# CITY OF ALBUQUERQUE

Re: **Gyro Shack**  
**4201 San Mateo Blvd. NE**  
**Traffic Circulation Layout**  
Engineer's/Architect's Stamp XX-XX-XX (G17-D024)

Based upon the information provided in your submittal received 09-22-22, the above referenced plan cannot be approved for Building Permit until the following comments are addressed:

ENGINEER'S SEAL	GYRO SHACK ALBUQUERQUE, NM	DRAWN BY JL
	TRAFFIC CIRCULATION LAYOUT	DATE 9-15-22
		DRAWING
		SHEET #
RONALD R. BOHANNAN P.E. #7868	TIERRA WEST, LLC 5571 MIDWAY PARK PL NE ALBUQUERQUE, NEW MEXICO 87109 (505) 858-3100 www.tierrowestllc.com	JOB # 2022101

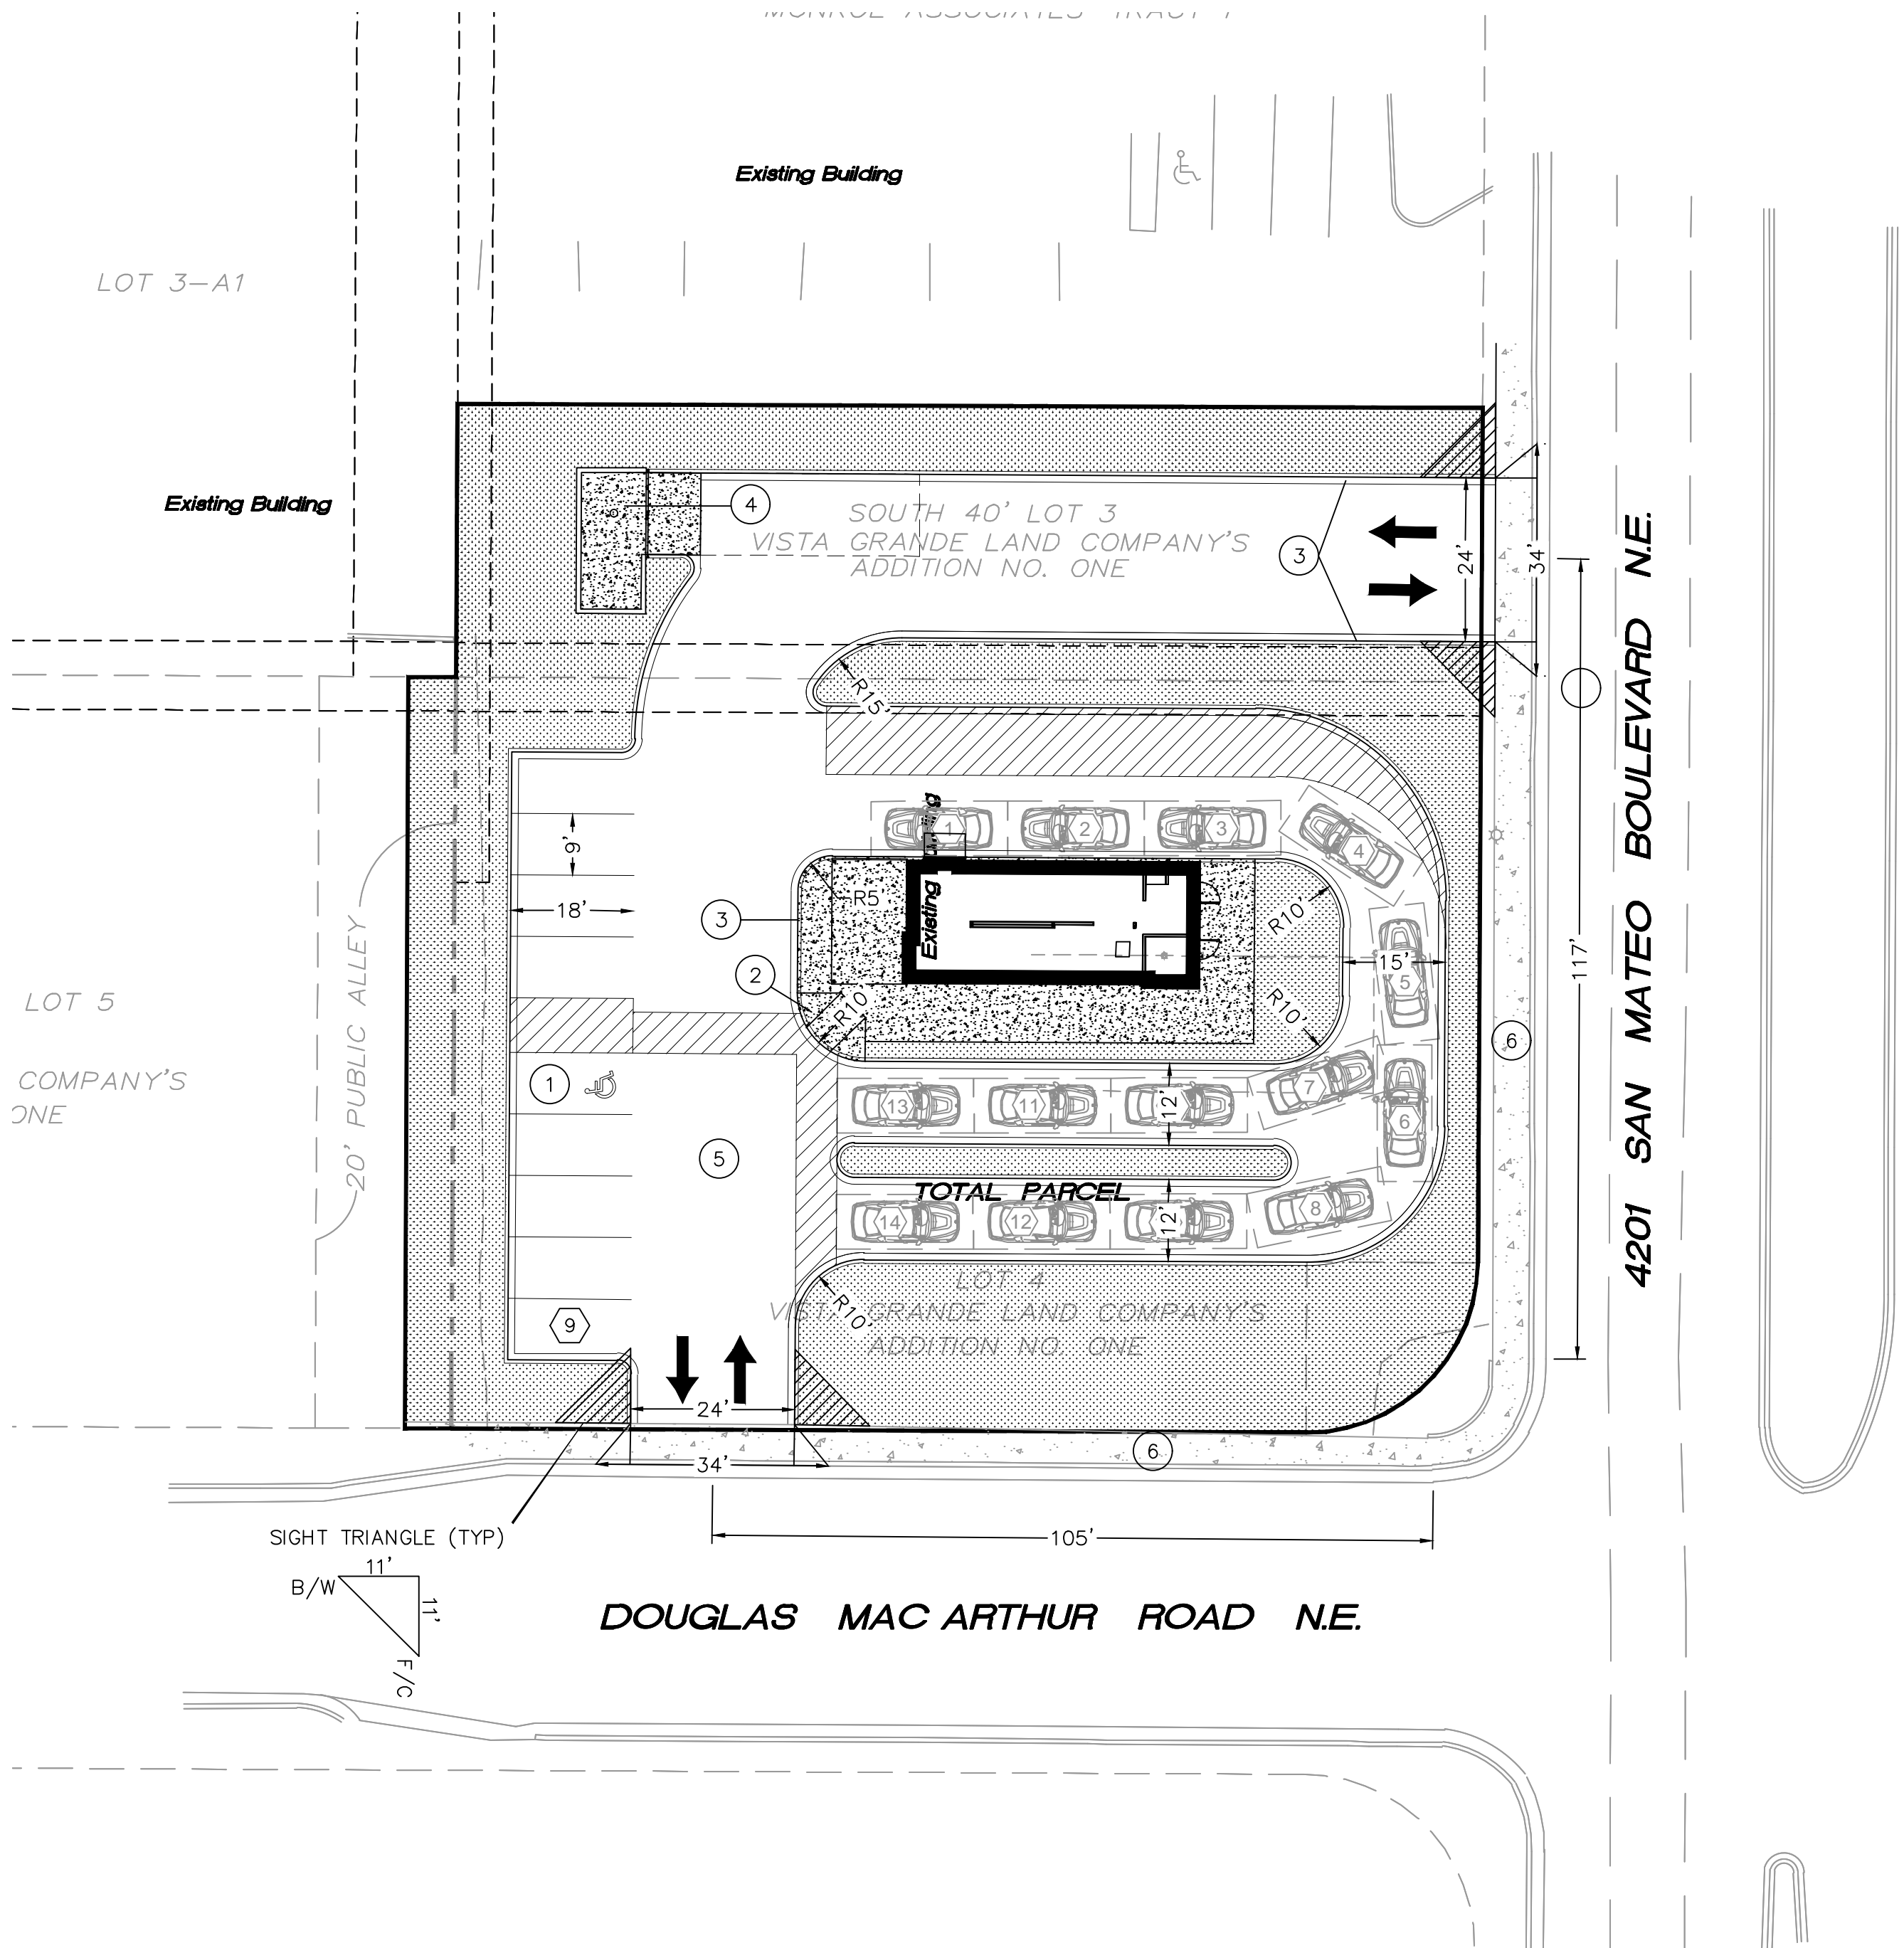
1. List the number of Motorcycles and Bicycles parking spaces required by the IDO.
1. The traffic circulation layout must be stamped, signed, and dated by an engineer or architect licensed in the state of New Mexico.

2. Identify the right of way width, medians, curb cuts, and street widths on San Mateo Blvd. and Douglas Mac Arthur Rd.
3. Clarify existing property lines and proposed property lines.

4. A curb return design is required for the both driveway accesses. Please provide details.
5. The ADA accessible spaces must include an access aisle. Van accessible aisles should be 8ft wide; all others should be 5ft wide.

6. The ADA accessible parking sign must have the required language per 66-7-352.4C NMSA 1978 **"Violators Are Subject to a Fine and/or Towing."** Please call out detail and location of signs.

7. The ADA access aisles shall have the words **"NO PARKING"** in capital letters, each of which shall be at least one foot high and at least two inches wide, placed at the rear of the parking space so as to be close to where an adjacent vehicle's rear tire would be placed. (66-1-4.1.B NMSA 1978)

8. ADA curb ramps at the corner of San Mateo and Douglas Mac Arthur must be updated to current standards and have truncated domes installed.
9. Key note 2: please provide details for the proposed ramp.

10. Motorcycle parking spaces shall be designated by its own conspicuously posted upright sign, either free-standing or wall mounted per the zoning code.

- 17. Per the IDO, a 6 ft. wide ADA accessible pedestrian pathway is required from the public sidewalk to the building entrances. Please clearly show this pathway and provide details.

- 18. Per DPM, a 6 ft. wide ADA accessible pedestrian pathway is required from the ADA parking stall access aisles to the building entrances. Please clearly show this pathway and provide details.

- 19. ADA accessible pedestrian pathway should not be placed behind parking space or adjacent to a vehicular way. Vehicle and pedestrian/wheel chair conflicts should be avoided as much as possible.

- 20. Curbing should be installed to delineate landscape, parking, and pedestrian ways and identify points of access. Please call out detail and location of barrier curb.

- 21. Parking areas shall have barriers to prevent vehicles from extending over public sidewalk, public right-of-way, or abutting lots.
- 22. Refuse vehicle maneuvering shall be contained on-site. The refuse vehicle shall not back into the public right of way.; provide a copy of refuse approval.

- 23. Provide a copy of Fire marshal approval.
- 24. All one-way drives shall have "One Way" and "Do Not Enter" signage and pavement markings. Please show detail and location of posted signs and striping.

25. The minimum drive through lane width is 12 feet with a 25 foot minimum radius (inside edge) for all turns. (A 15 foot radius can be used with an increase in lane width to 14 feet). Please dimension all lane widths and radii.

26. Please specify the City Standard Drawing Number when applicable.
27. Unused curb cuts must be replaced with sidewalk and curb & gutter. A build note must be provided referring to the appropriate City Standard drawing.

28. Add a note stating "All broken or cracked sidewalk must be replaced with sidewalk and curb & gutter." A build note must be provided referring to the appropriate City Standard drawing.
